To: Urban Design Committee  
From: Planning and Preservation Division  
Date: July 3, 2018  
RE: **Final Location, Character, and Extent Review of modifications to Hull Street, from Chippenham Parkway to Arizona Drive; UDC 2018-28**

The application is for final location, character, and extent review of modifications to Hull Street, from Chippenham Parkway to Arizona Drive.

*Typical section proposed in the Hull Street Corridor Revitalization Plan (page 97)*

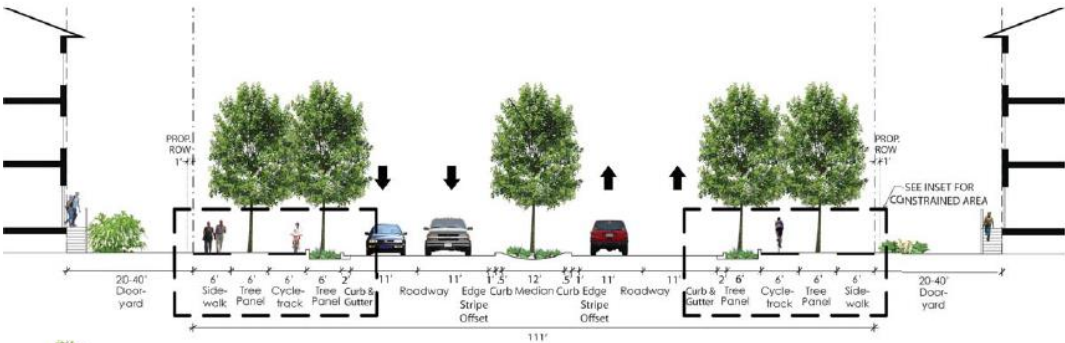
The proposed typical section includes: a continuous pedestrian sidewalk network and crossings; a separated cycle track/bicycle way on each side of the corridor; a landscaped buffer between pedestrians and bicycle way and travel way that provides sufficient space for comfortable and furnished transit stops and amenities; a landscaped median that provides accommodation of left turn lanes at intersections to reduce rear end and rear-angle crashes; and provide safe pedestrian crossings with a minimum 6’ pedestrian refuge even when the median is reduced to provide a left turn pocket; two travel lanes in each direction to maintain vehicular capacity and operation; and a gutter pan that can channelize water into low impact development (LID) features in the planting buffer (page 97).
